**JUNE 2021 FINAL MND SCH #2020100267**

**JUNE 2021 FINAL MITIGATED NEGATIVE DECLARATION/INITIAL STUDY  
FOR AMERESCO KELLER CANYON RNG LLC – PROPOSED RENEWABLE  
NATURAL GAS PROCESSING FACILITY AND PIPELINE PROJECT  
SCH #2020100267  
LAND USE PERMIT LP18-2022  
JUNE 23, 2021**

This document constitutes the Final Mitigated Negative Declaration/Initial Study (MND), State Clearinghouse SCH #2020100267, for the Ameresco Keller Canyon RNG LLC – Proposed Renewable Natural Gas Processing Facility and Pipeline Project (Ameresco RNGPFP) in unincorporated Contra Costa County near Pittsburg, CA. The proposed project is a renewable natural gas (RNG) processing facility (RNGPF) and pipeline that includes construction and operation of a new RNGPF and an underground transmission pipeline. The Final MND includes a revised project description, summary responses addressing the project description and potential impacts, the written comments received on the November 2020 re-noticed draft MND, responses to the comments received, and staff-initiated text changes including changes resulting from the preparation of responses to comments received and revised and/or deleted figures. The text changes are

**FIGURE 9 - PIPELINE PLAN (REVISED)**

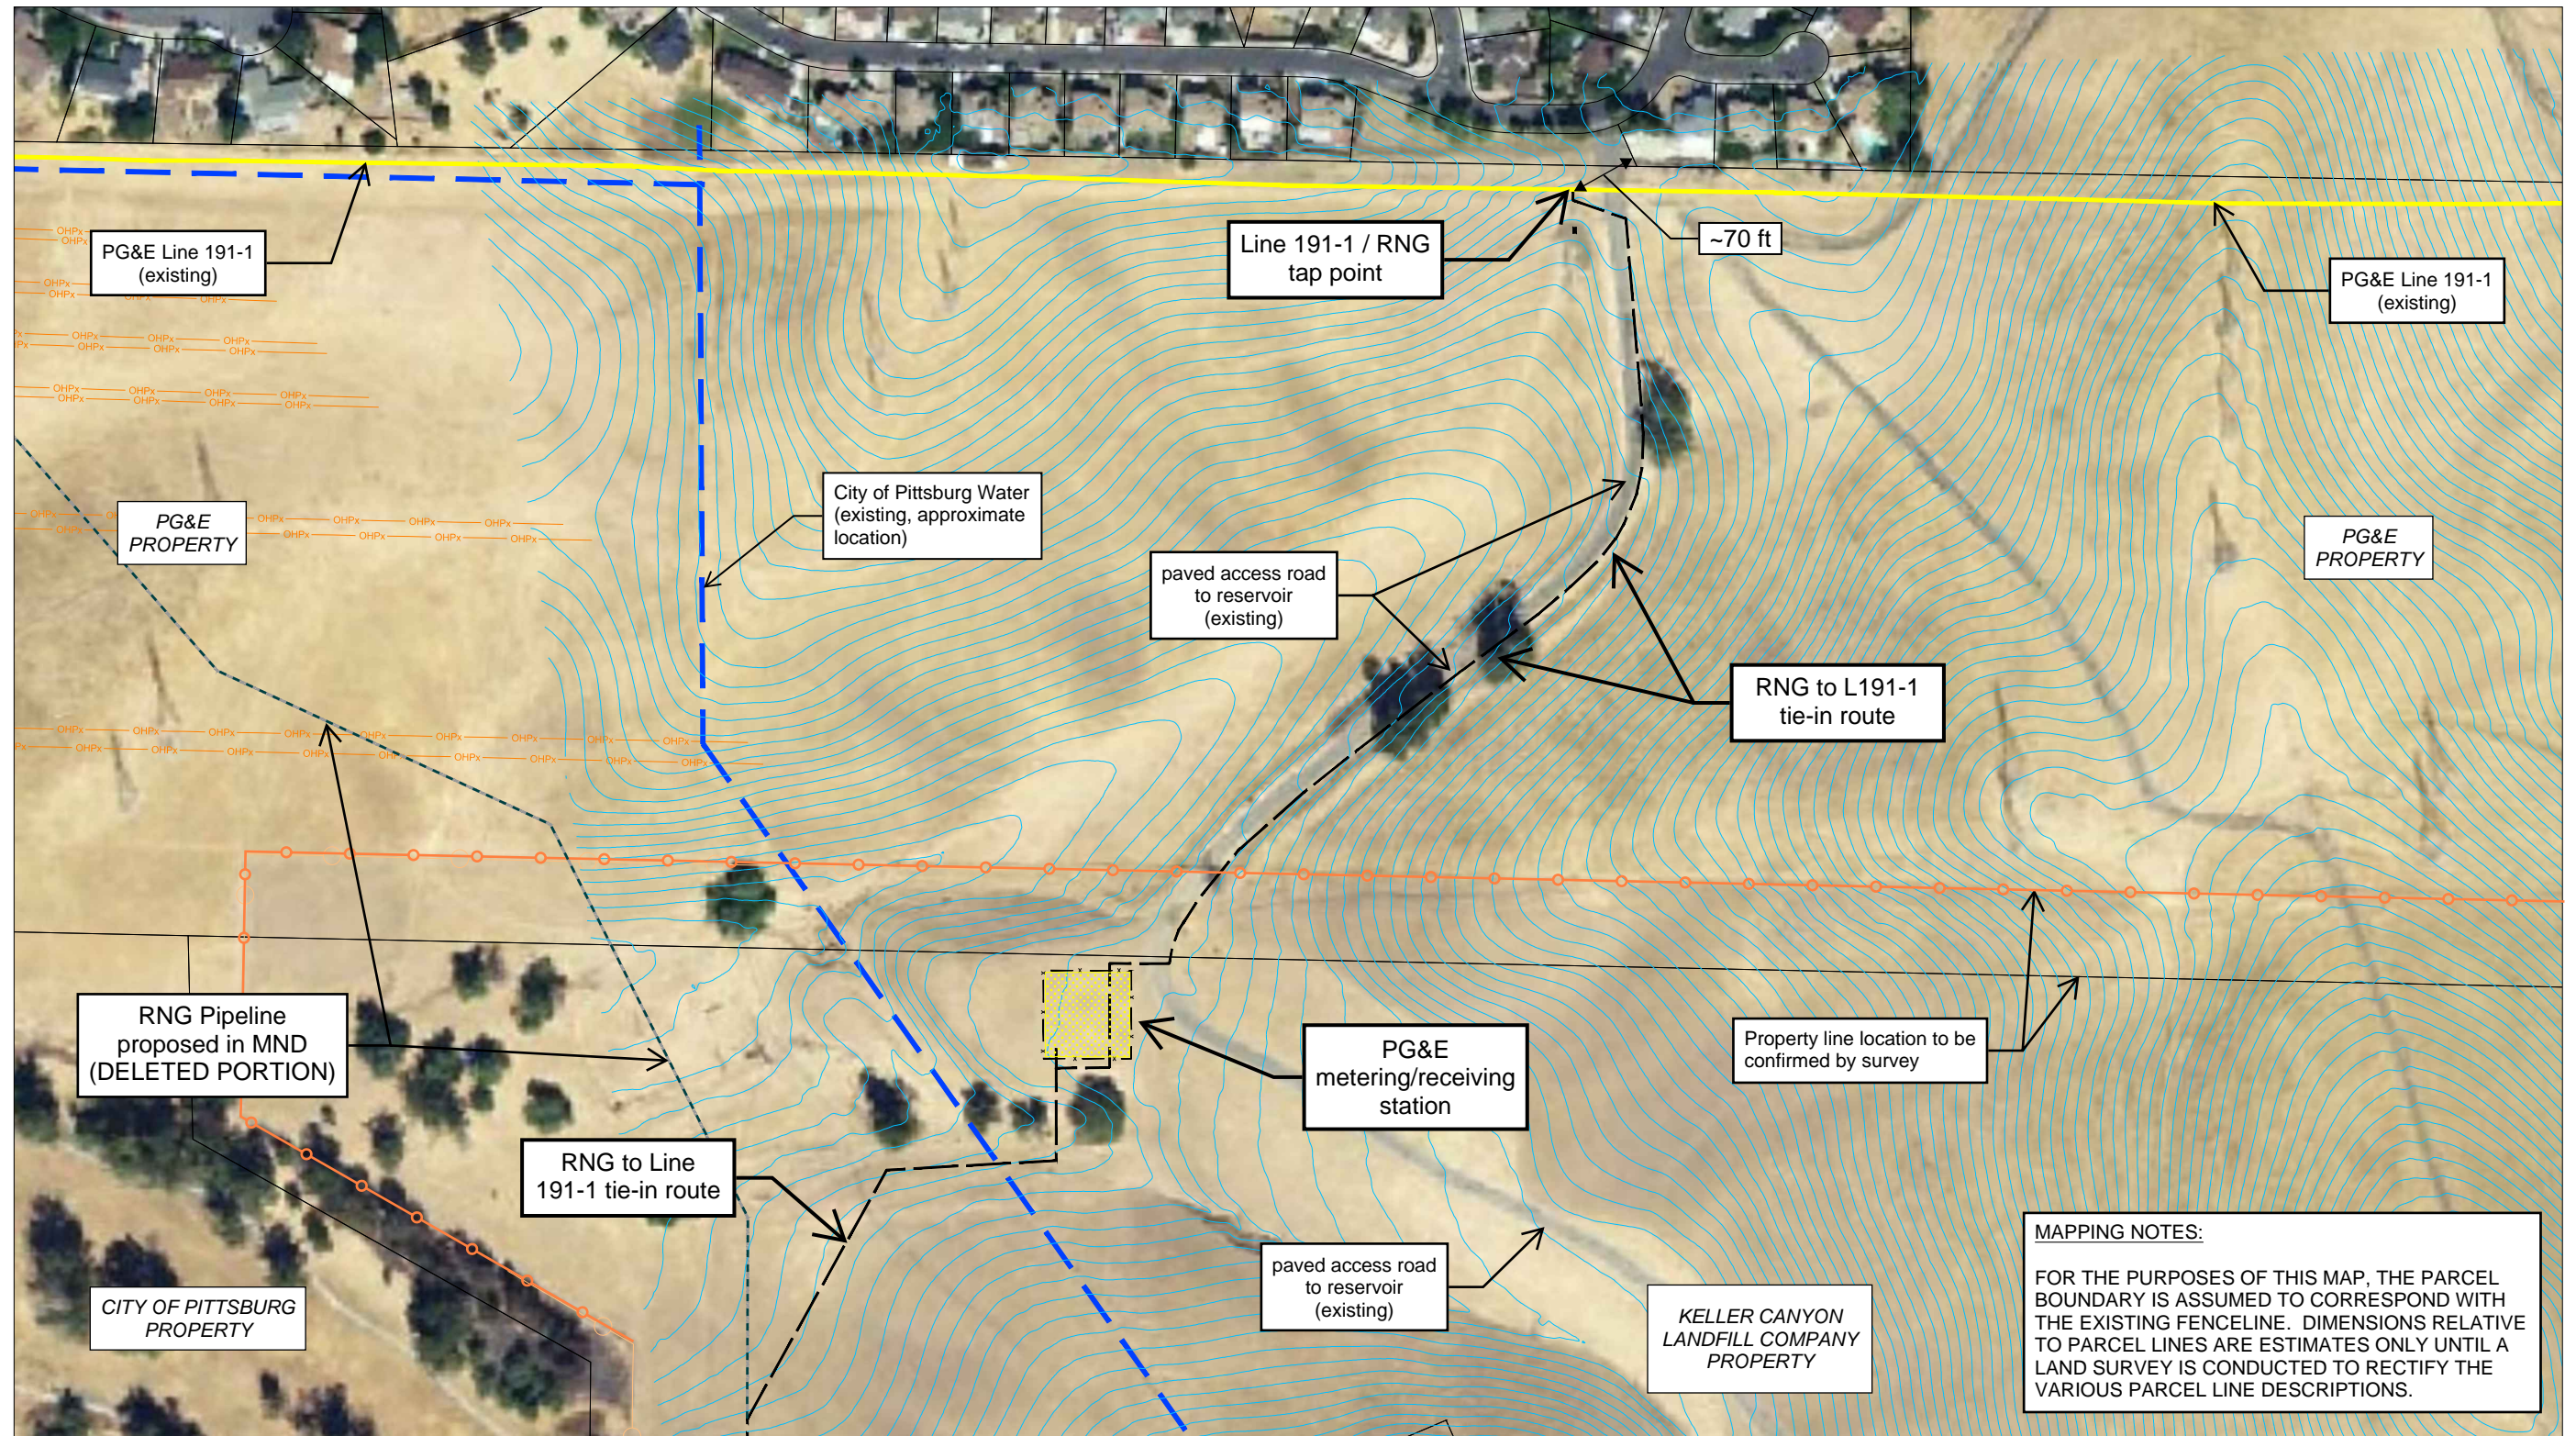
• Figure 5 RNGPF Site Plan, pg. 23 .....	Revised site plan/equipment layout
• Figure 6 General Arrangement, pg. 24 .....	Revised equipment arrangement
• Figure 9 Pipeline Plan, pg. 30 .....	Revised pipeline alignments

The proposed pipeline will connect the proposed RNG processing facility to a proposed PG&E metering station and the existing PG&E STANPAC 3 ~~gas transmission pipeline~~ Line 191-1. The proposed pipeline plan is shown on revised Figure 9. The proposed pipeline route through the PG&E utility corridor is shown on revised Figure 10. The pipeline will be buried underground and will be a four-inch steel-wrapped pipe designed for operation at an estimated pressure of 400 ~~680~~ pounds per square inch. The estimated total pipeline length is approximately 15,050 ~~18,030~~ lineal feet (LF) in plan or about 2.85 ~~3.4~~ miles. Two main pipeline segments are proposed:

**Figure 9-1 (Revised)**  
**Ameresco Keller Canyon RNG Pipeline**  
**Potential Impact Radius (PIR) of 55 feet**

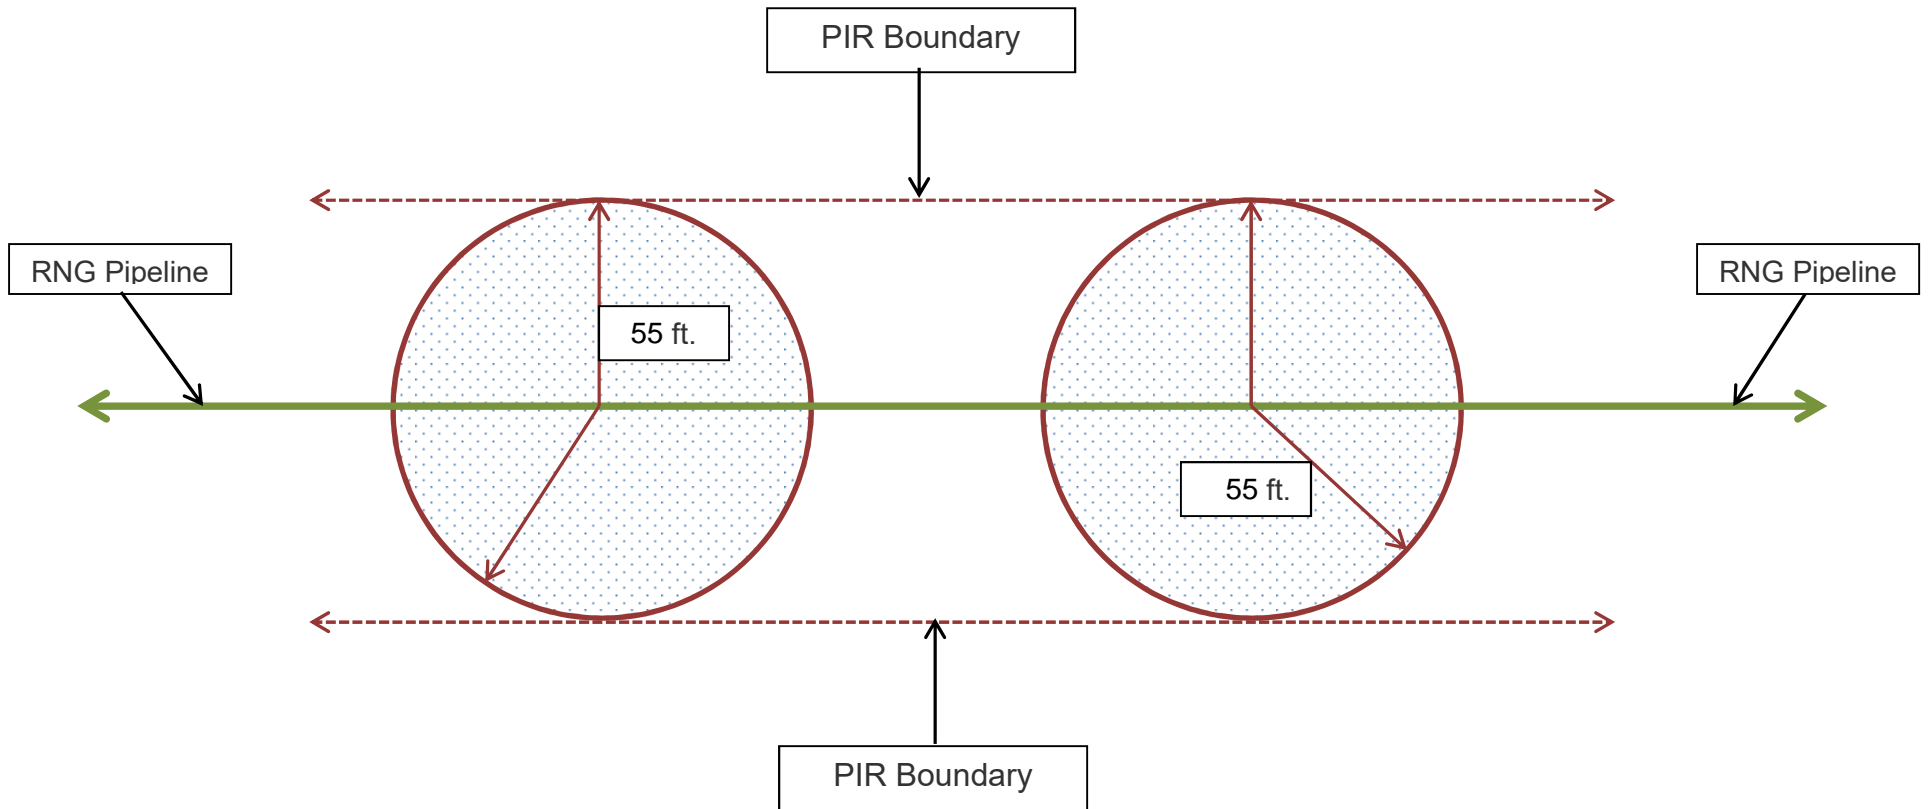
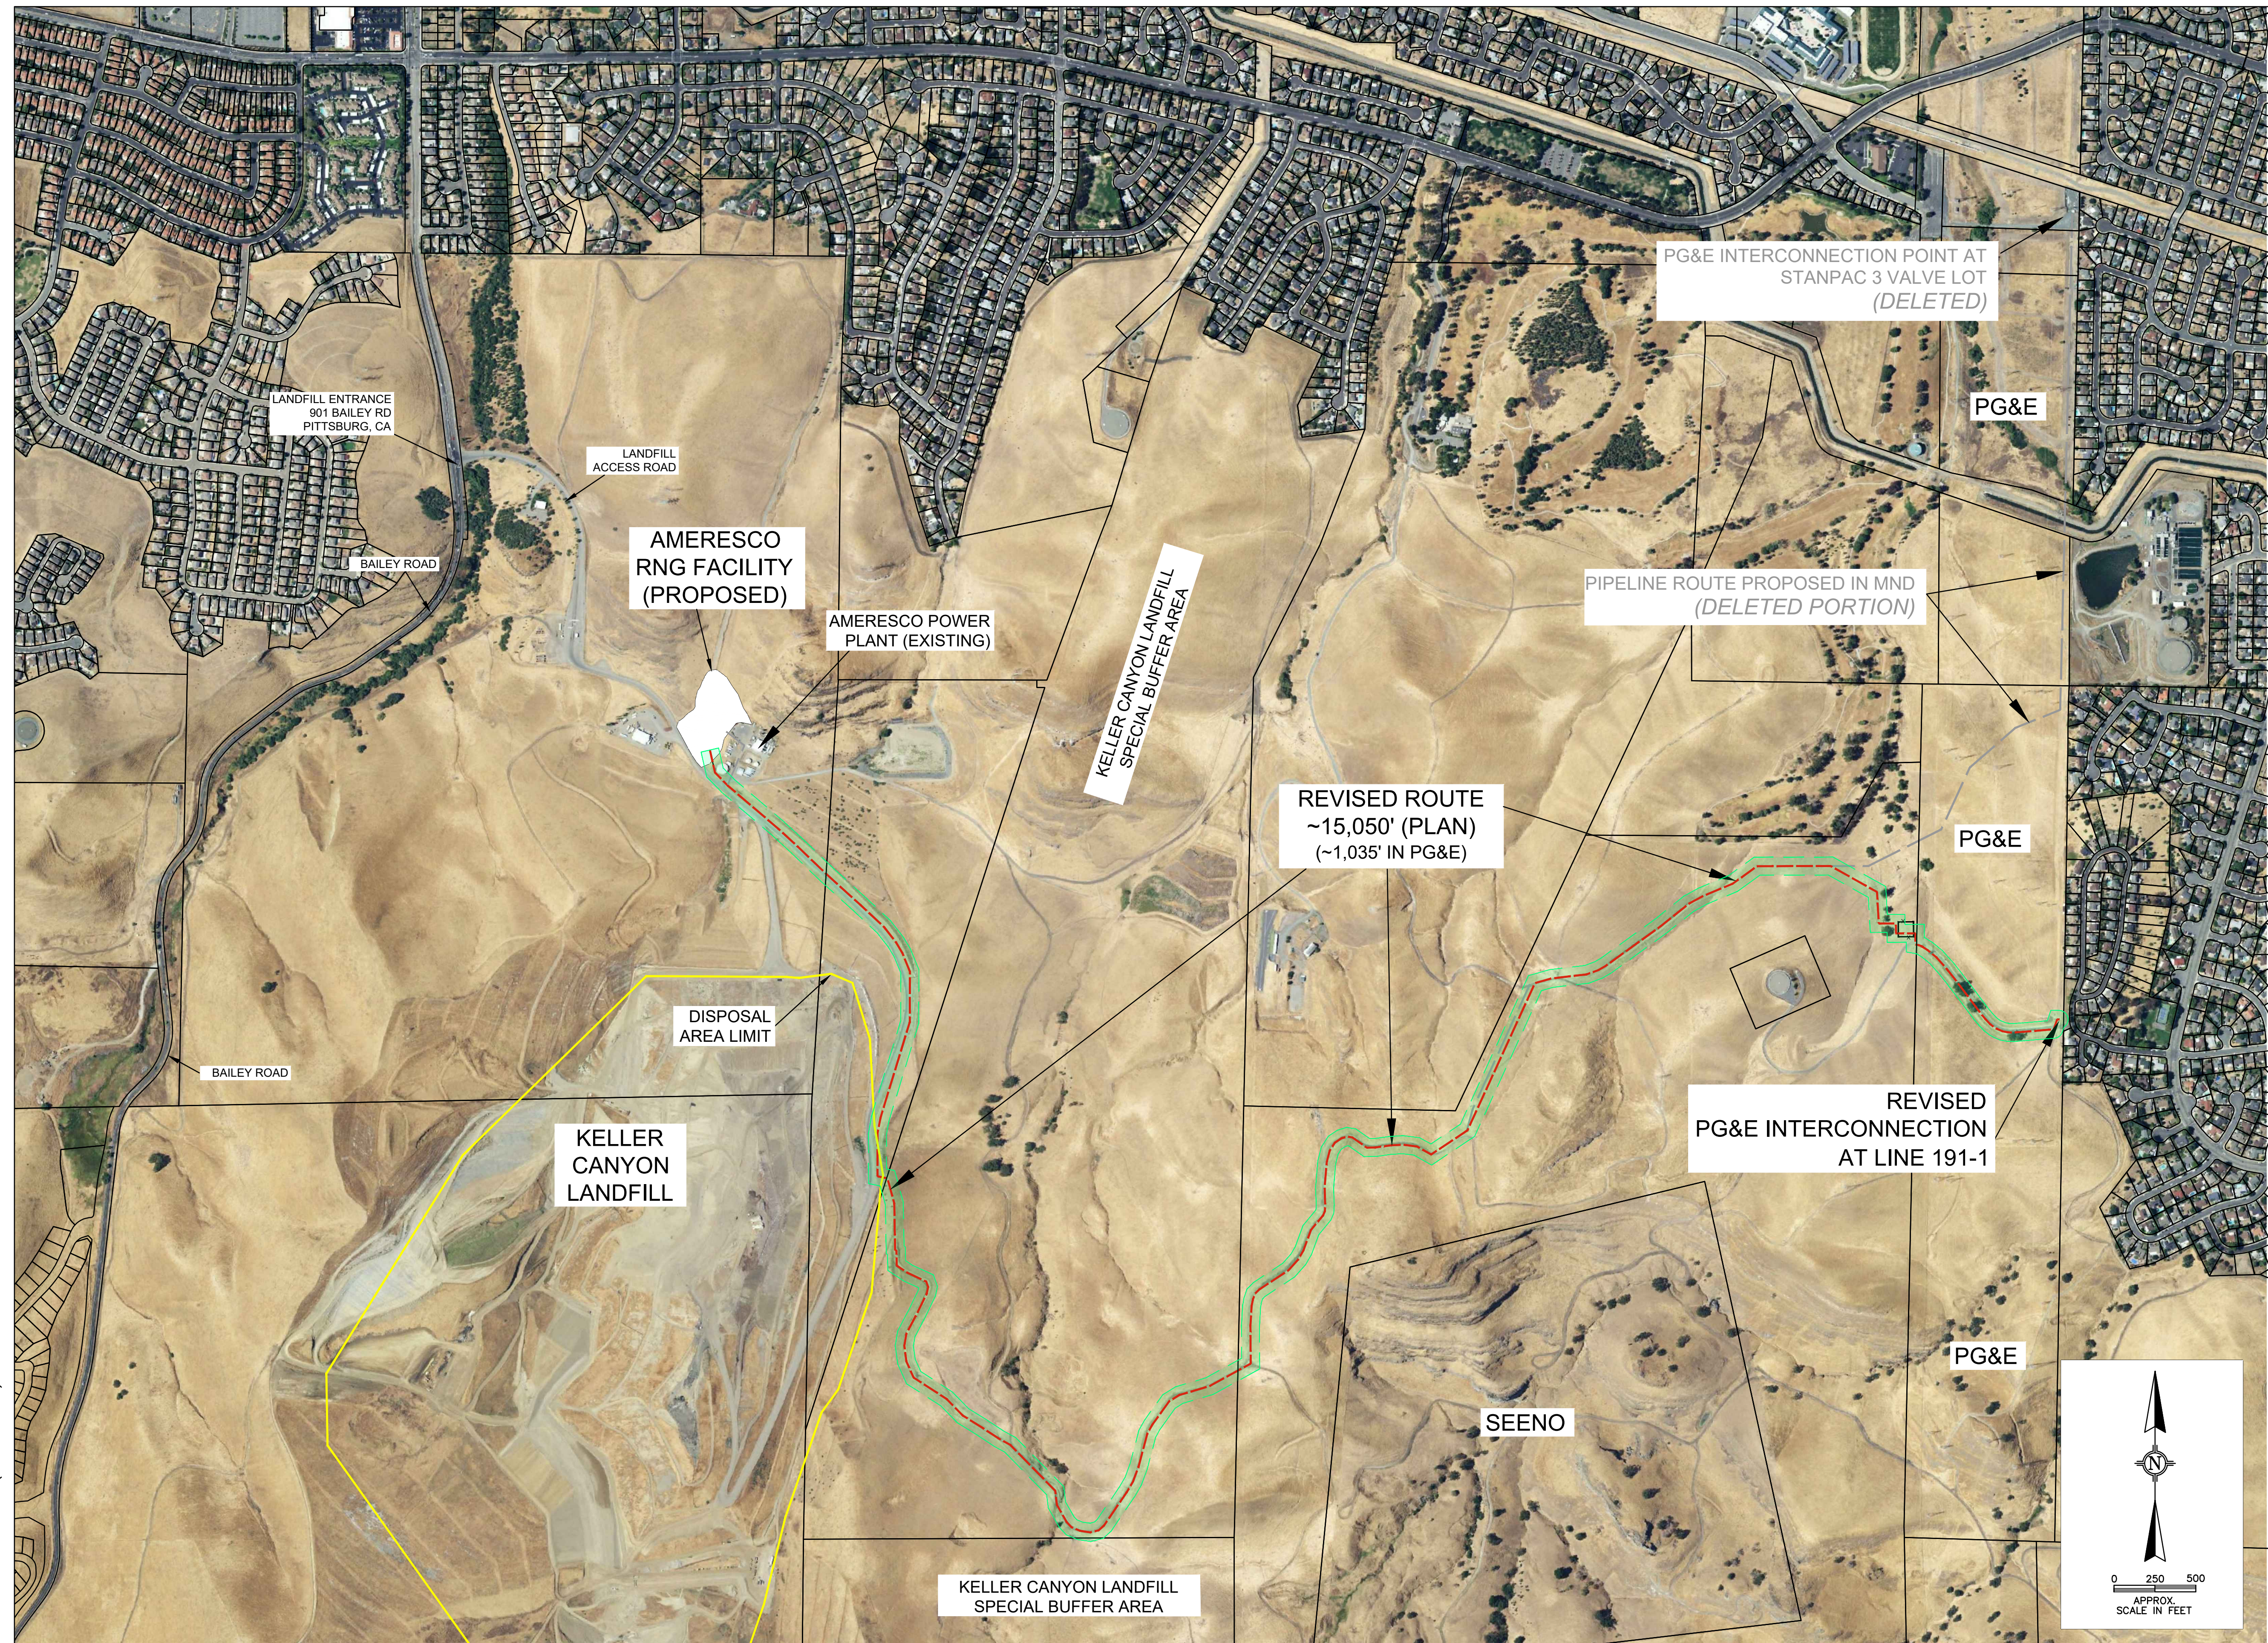
• Figure 17 PG&E Metering Station Isometric View, pg. 41 .....	Deleted
• Figure 18 Laydown Areas, pg. 42 .....	Revised for eliminated laydown areas
• Figure 9-1 Ameresco Keller Canyon RNG .....	Revised to show new PIR of 55 feet Pipeline PIR of 72 feet, pg. 172

Figure 9-1 (Revised) illustrates the relationship of the 55-foot PIR to the proposed pipeline. Figure 9-2 (Revised) (~~9100~~) illustrates the 55 ~~72~~-foot PIR for the entire pipeline system. The PIR is shown in green ~~orange~~ shading. ~~A detailed illustration of the 72-foot PIR for the PG&E property from the point where the pipeline would enter PG&E property to a point just north of the Contra Costa Canal is shown on Figure 9-3 (9101). The section of pipeline from north of the Contra Costa Canal to the PG&E STANPAC facility is shown on Figure 9-4 (9102).~~
